CERTIFICATE OF CORRECTION

Patent Number	:	10,221,780 B2
Issued	:	March 5, 2019
Name of Patentee	:	Sarder et al.
Title of Invention	:	DUAL FUEL LOCKOUT SWITCH FOR GENERATOR ENGINE

REQUEST FOR CERTIFICATE OF CORRECTION OF PATENT FOR OFFICE'S MISTAKE (37 CFR 1.322)

图 1

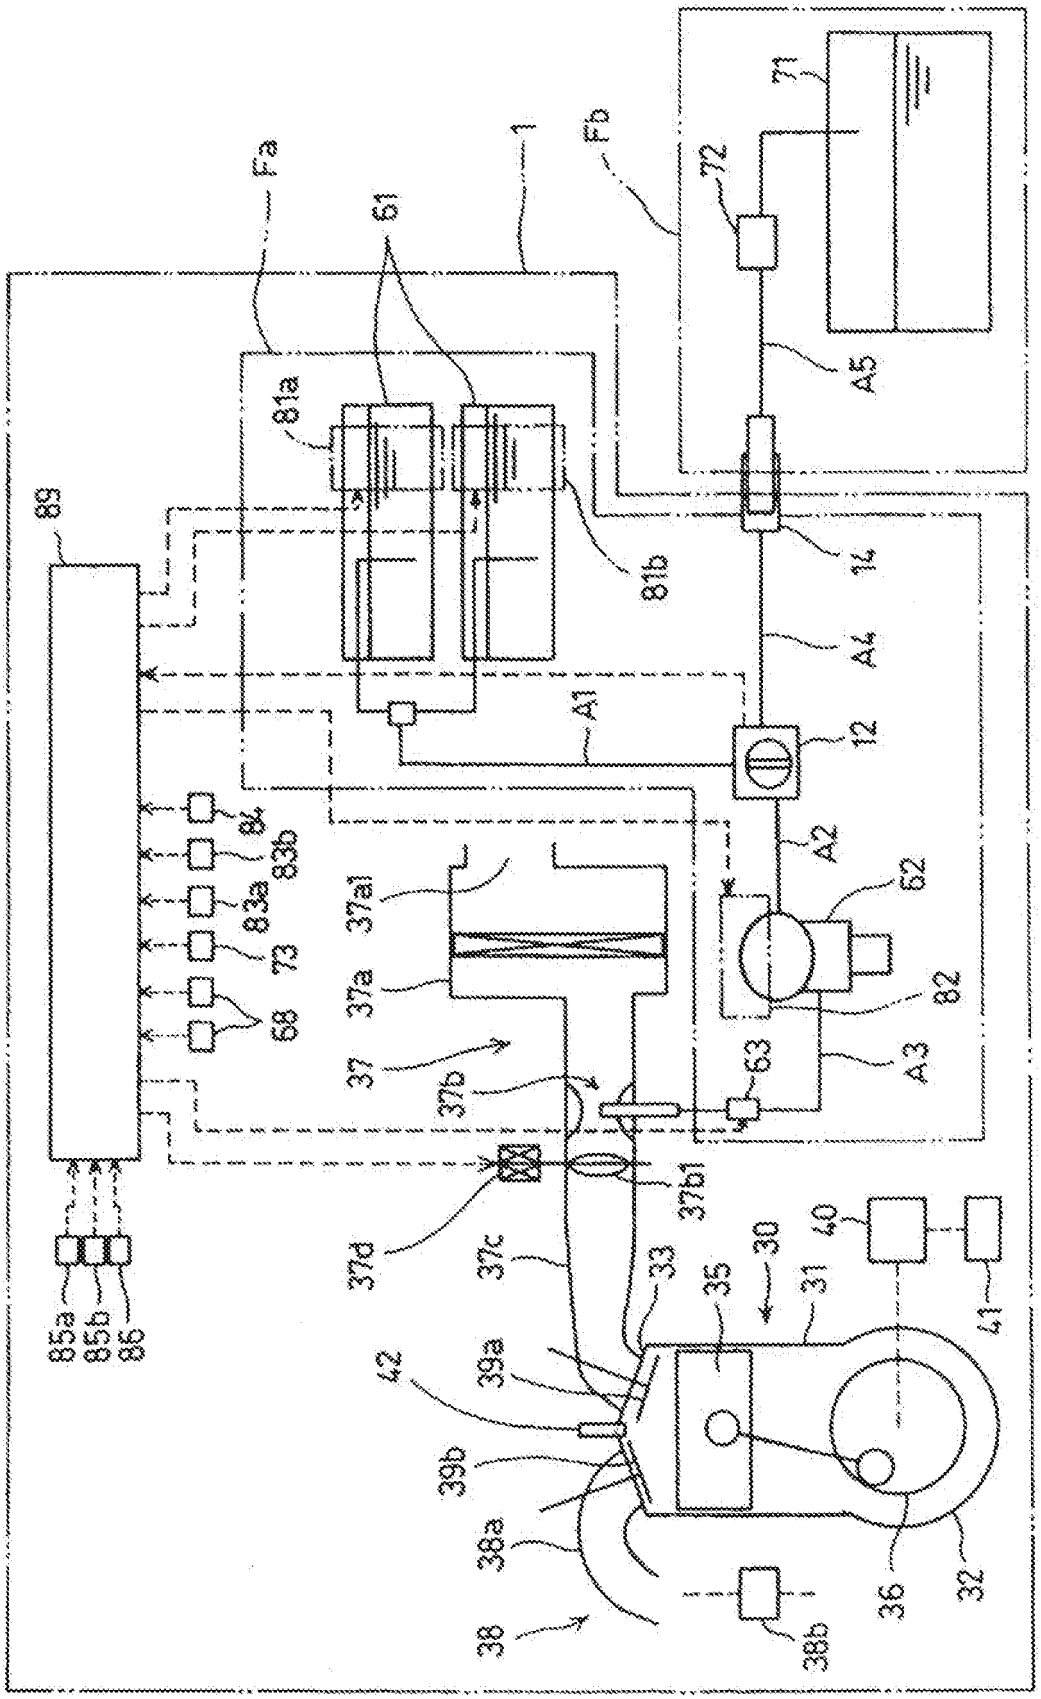
29. **Regarding claim 23,** the modified Pursifull discloses the method of claim 19, further comprising coupling a fuel regulator system to the second fuel source to reduce fuel pressure therefrom and deliver fuel to the second fuel line at a pressure required for operation of the internal combustion engine (Fig. 1 of Sugimoto shows the regulators in series reducing pressure).

30. **Regarding claim 24,** the modified Pursifull discloses the method of claim 23, further comprising mounting the fuel regulator system to the second fuel source located off-board the internal combustion engine (Fig. 1 of Sugimoto as modified onto Pursifull and shown).

31. **Regarding claim 25,** the modified Pursifull discloses the method of claim 23, further comprising: coupling one end of a quick-disconnect hose coupling to an inlet on the internal combustion engine for the second fuel source; and coupling a mating end of the quick-disconnect hose coupling to an outlet of the fuel regulator system (Fig. 1 of Sugimoto as modified onto Pursifull and shown).

29. **Regarding claim 23,** the modified Pursifull discloses the method of claim 19, further comprising coupling a fuel regulator system to the second fuel source to reduce fuel pressure therefrom and deliver fuel to the second fuel line at a pressure required for operation of the internal combustion engine (Fig. 1 of Sugimoto shows the regulators in series reducing pressure).

30. **Regarding claim 24,** the modified Pursifull discloses the method of claim 23, further comprising mounting the fuel regulator system to the second fuel source located off-board the internal combustion engine (Fig. 1 of Sugimoto as modified onto Pursifull and shown).

the quick-disconnect hose coupling to an outlet of the fuel regulator system (Fig. 1 of Sugimoto as modified onto Pursifull and shown).
